Acoustic response to SSDA submissions

The Department of Planning, Industry and Environment (DPIE) has received a number of submissions regarding the development application for the Upgrades to John Palmer Public School (JPPS) (SSD-23330227). A submission was provided by Higgins Planning, dated 10 November 2021, on behalf of ISPT Limited. This letter provides a response to the noise related items within that submission.

Figure 2 Measurement locations

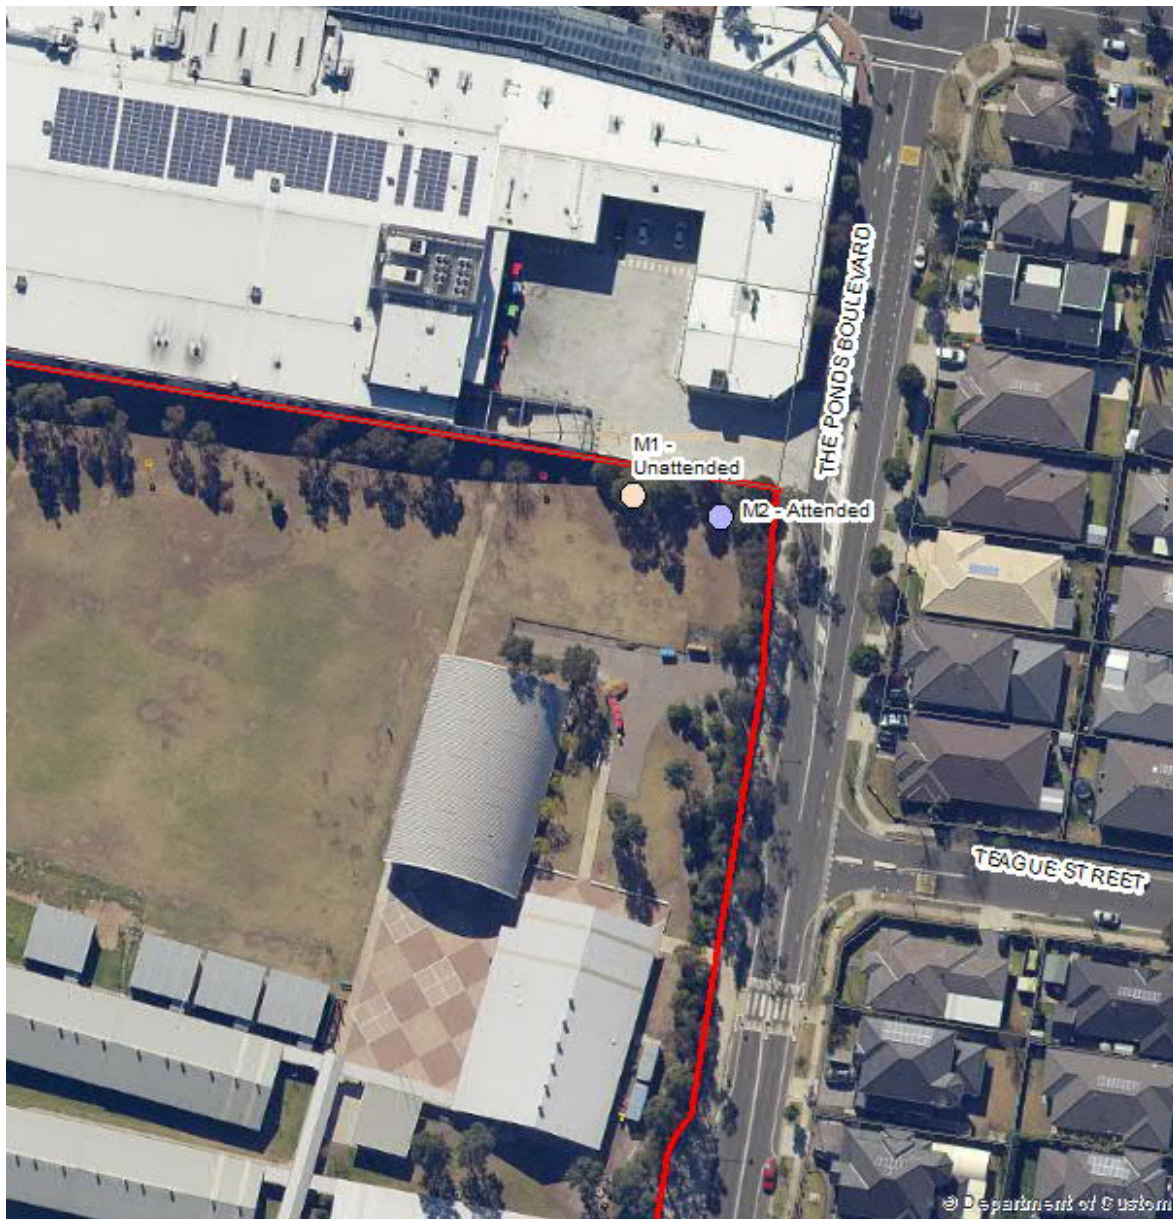
2.3 Proximity of the proposed building to The Ponds shopping centre loading dock

....ISPT cannot find what / if any, mechanisms are to be included in the design of the proposed new building to ensure any noise associated with trucks servicing the loading dock are

maintained during the operations of The Ponds. That is what noise attenuating walls and their locations are proposed along the northern boundary of the school site to mitigate impacts of locating the 3-storey building which includes learning areas and classrooms.

ISPT request information be provided and designed into the proposal given that the school seeks to locate in close proximity to an existing site condition such that the introduction of the proposed school building will not result in complaints being lodged with Council or the Department by the school.

To determine the existing noise levels from The Ponds Shopping Centre at outdoor play areas and at the proposed new buildings, noise monitoring was conducted at the approximate location of the proposed new building closest to The Ponds Shopping Centre. The noise logger was placed at the Location M1 shown in Figure 2 between Thursday 16 December and Wednesday 22 December 2021. The noise monitor was placed at approximately 4 metres above ground level. An attended measurement was also conducted between 1.45 pm and 2.00 pm on 22 December 2021, at M2 in Figure 2 at approximately 1.5 metres above the ground for a 15 minute period to understand the impact of various sources on the outdoor play areas.

The unattended measured $L_{Aeq,9hr}$ noise level at location M1 was 58 dB(A) during the daytime over the five day measurement period. The $L_{Aeq,15min}$ noise level ranged between 54 dB(A) and 61 dB(A) during the measurement period.

The attended measured $L_{Aeq,15min}$ noise level at location M2 was 54 dB(A) during the measurement period. The noise level at M2 include noise from road traffic on The Ponds Boulevard, vehicles entering and exiting the car park, three trucks and activities in the loading dock and vacation care children in the outdoor play area. During the attended measurement period noise from loading dock activities was subjectively not considered to be intrusive in the outdoor area. During the attended measurement, the noise level from cars entering the underground car park was similar to the noise level from traffic on The Ponds Boulevard.

It should be noted that an existing precast concrete wall is located on the boundary between TPSC loading dock and the proposed new buildings. The existing concrete wall ranges from 1.5 metres to 3.5 metres in height in the area of the proposed new buildings.
